Technical Service Bulletin

Component Change

TSB-MBS-1013

Subject: Habonim Extended Stem Ball PB Valve on Perma-Cyl Vessels

1- Worcester Cryogenic Valve (Ext. stem or short stem)

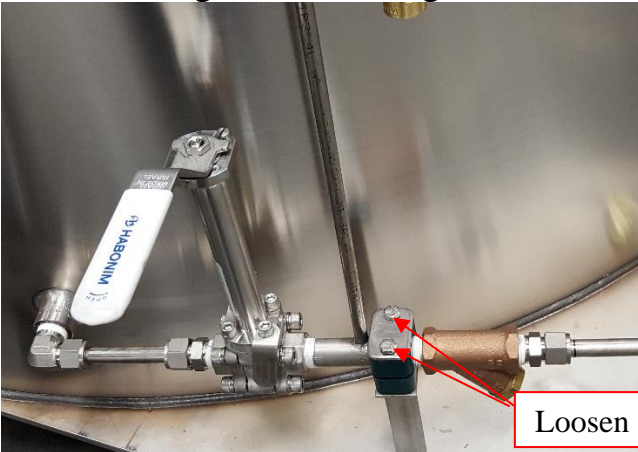
Resolution: Any Habonim valve that does not have the Duncan sticker at the bottom of the valve stem, should be removed from the tank and replaced. Chart will issue an RMA and send out a replacement valve. Valves with or without the Duncan sticker that are currently in service and show no signs of leaks are okay to keep in service. For tanks currently in process, Chart has decided to go back to the original short stem cryogenic Worcester valve for the short term and eventually change to an extended stem version of this same Worcester valve. The Worcester valve is a direct replacement for the extended stem Habonim valve and should fit using the same pipe fittings. Installation instructions for changing out this valve are included in this bulletin. Chart also suggests running some cryogenic liquid through the valve during the first fill to insure there are no leaks prior to completely filling the tank.

Part Number 20897965

Part Number 1712202

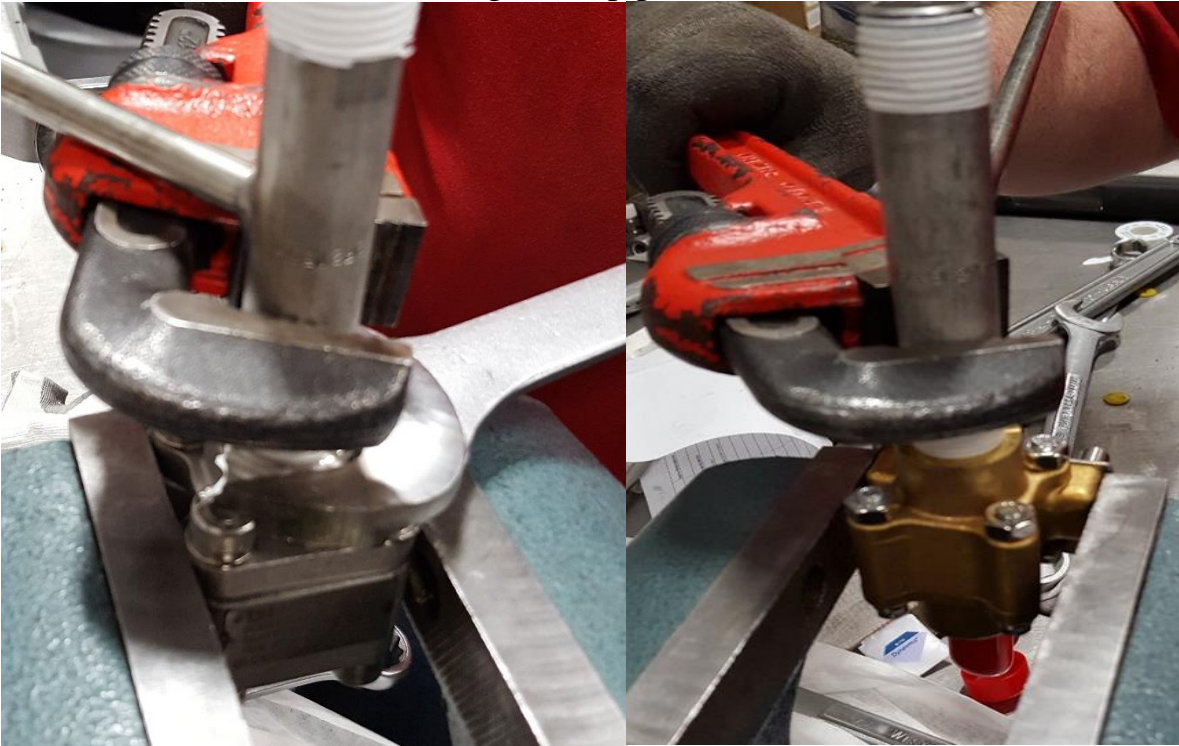
After draining the tank, using 7/16 wrench loosen and remove the two Stauff clamp bolts.

Loosen Stauff clamp

Next loosen the Swagelok fittings.

Remove Swagelok Fittings

Remove the assembly from the tank. Place valve assembly in the vice, remove the fitting and the relief valve nipple. Valves with screwed ends should be treated as a single unit and should not be dismantled when installing in the pipeline.

The flow arrow on the valve should be pointing towards the relief nipple.

Clean all threads. Apply the appropriate thread tape to the nipple and the compression fitting. Install fittings into the valve as pictured. When tightening the valve, apply a bench vice or a pipe wrench to the end connector closest to the pipe fitting being worked using standard piping practices. (Note: see photo on how the valves are held in the bench vice.)

The short stem Worcester ball valve is to be installed in this position to avoid interference with the relief valve tube and outer shell.

The extended stem Worcester ball valve is to be installed in this position to avoid interference with the relief valve tube and outer shell. The valve is angled approximately 20-25 degrees from horizontal. The maximum incline for the extended stem valve is 45 degrees from horizontal.
